Application for Works Approval

Works Approval Number	W3110/2025/1
Applicant	Gold Valley Wiluna West Pty Ltd
ACN	673 280 530
File number	APP-0031200
Premises	Wiluna West Project Sandstone-Wiluna Road, Wiluna Legal description Part of Mining Tenement L53/115, L53/146 and M53/1078 - I As defined by the coordinates in Schedule 1 of the works approval
Date of report	10 February 2026
Decision	Works approval granted

Figure 4: Distance to Priority Ecological Community

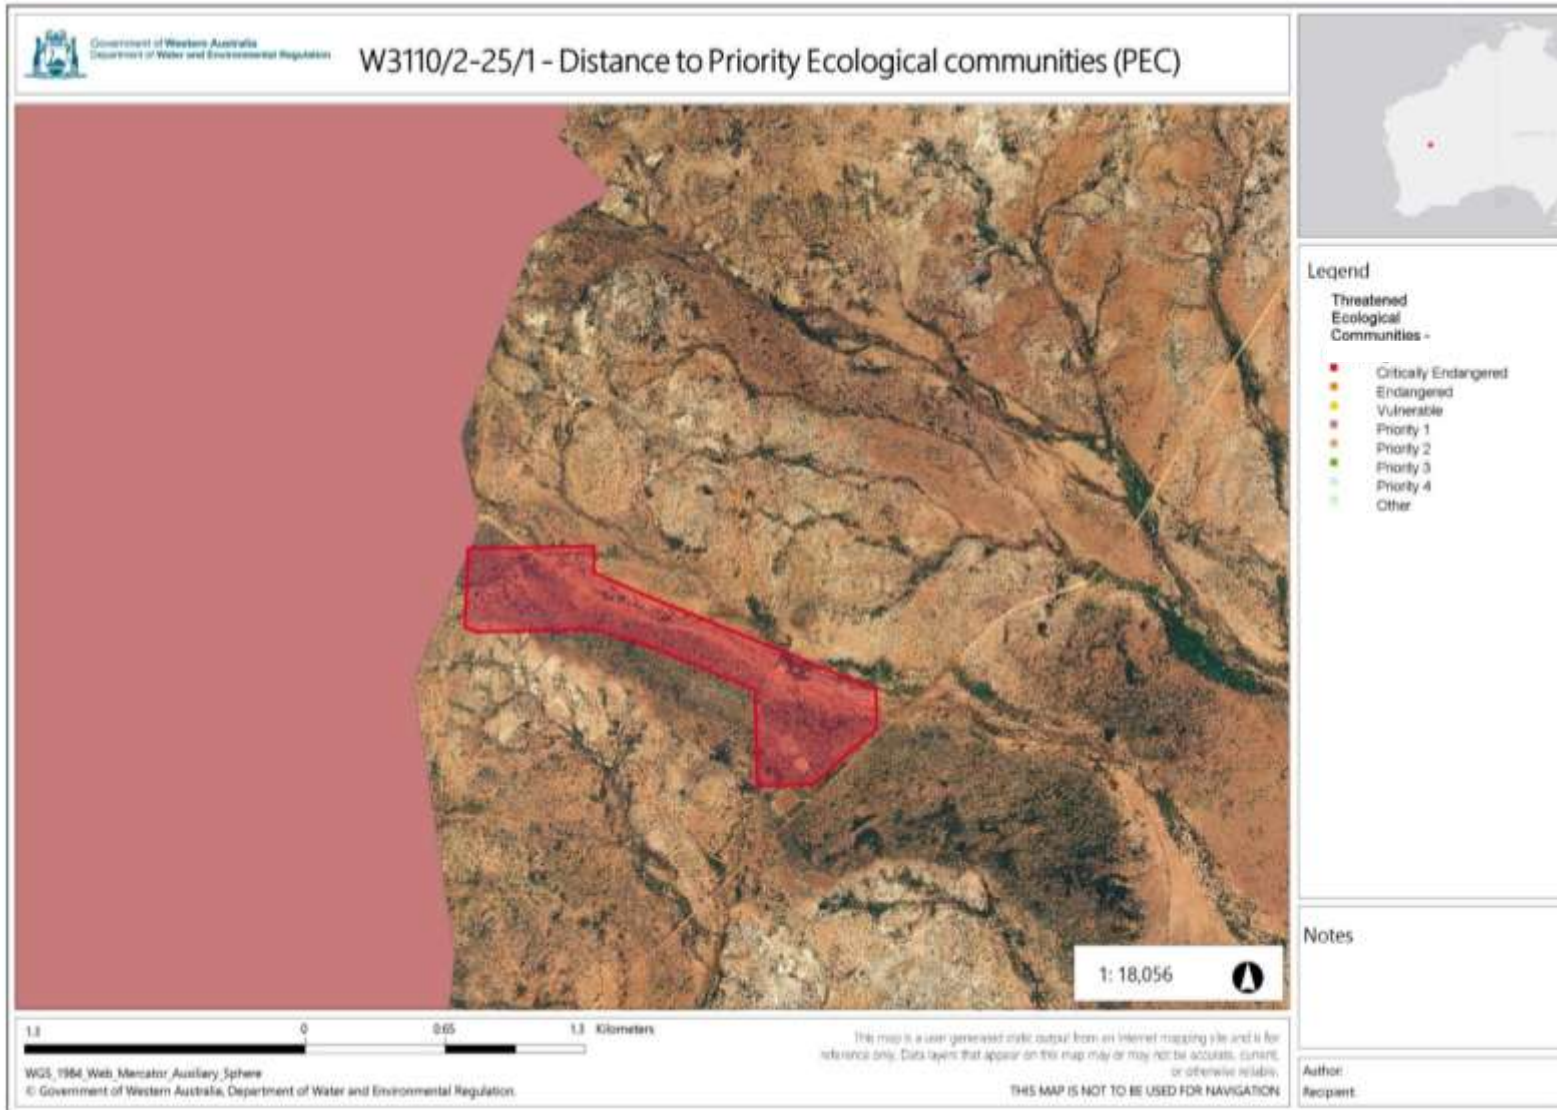
Stakeholder comments	Department response
<p>Priority Ecological Communities</p> <p>The stakeholder is concerned that the application does not adequately assess indirect impacts on the Wiluna West vegetation complexes Priority Ecological Community (PEC), which is listed as Priority 1. While the applicant acknowledges that disturbance within the PEC buffer is limited to 0.3 hectares along the pipeline corridor, the assessment overlooks potential edge effects, hydrological changes, and weed invasion risks. Additionally, there is insufficient analysis of how treated effluent irrigation for dust suppression might affect groundwater quality and connectivity in Banded Iron Formation (BIF) systems, which are highly sensitive ecosystems supporting unique endemic species.</p> <p>The stakeholder recommends prohibiting treated effluent application within a specified buffer distance from the Priority 1 Ecological Community and documented Priority 3 flora populations to prevent potential ecological impacts.</p>	<p>The Department acknowledges the stakeholder's concerns regarding potential indirect impacts on the Wiluna West vegetation complexes Priority Ecological Community (PEC), and notes that the proposed premises boundary shows only a minimal overlap (85 m²) with the mapped PEC (refer to Figure 4). Furthermore, the proposed infrastructure, including the wastewater treatment plant (WWTP), pipeline, and turkey nest, does not overlap with the PEC, and the turkey nest is located more than 100 metres away from the PEC. The applicant has also proposed that treated wastewater will be applied exclusively on haul and access roads within their mining tenements.</p> <p>The proposed turkey nest is existing infrastructure and is located within the PEC 500 m buffer zone, along with a small section of the pipeline corridor (approximately 0.3 hectares). The delegated officer has carefully considered these matters during the assessment and determined that, given the distance to the PEC and the absence of infrastructure within the PEC, the risk of indirect impacts is low. To minimise risks, the delegated officer has imposed conditions in the works approval requiring the turkey nest to be maintained with a low-permeability liner and adequate freeboard to prevent unauthorised discharges. Additional conditions address spill management, leakage prevention, and overflow controls.</p> <p>The Department also notes that the Department of Mines, Petroleum and Exploration (DMPE) has applied complementary management measures, including V-drains along the pipeline and daily inspections of infrastructure, which are considered adequate to meet DMPE's environmental objectives.</p> <p>Hydrogeological information indicates that the regional groundwater flow direction is generally easterly toward Lake Way, with only minor localised variations near the Banded Iron Formation (BIF) ridges (B and C ridges). This flow pattern reduces the likelihood of treated effluent migration toward the PEC. Furthermore, conditions have been applied to ensure environmental protection, including requirements for wastewater treatment plant construction standards, treated effluent monitoring, and authorised discharge locations for dust suppression. Emission and discharge limits have been set for both the commissioning and time-limited operational phases. The proposed dust suppression areas are located well away from the PEC, further minimising risk.</p>
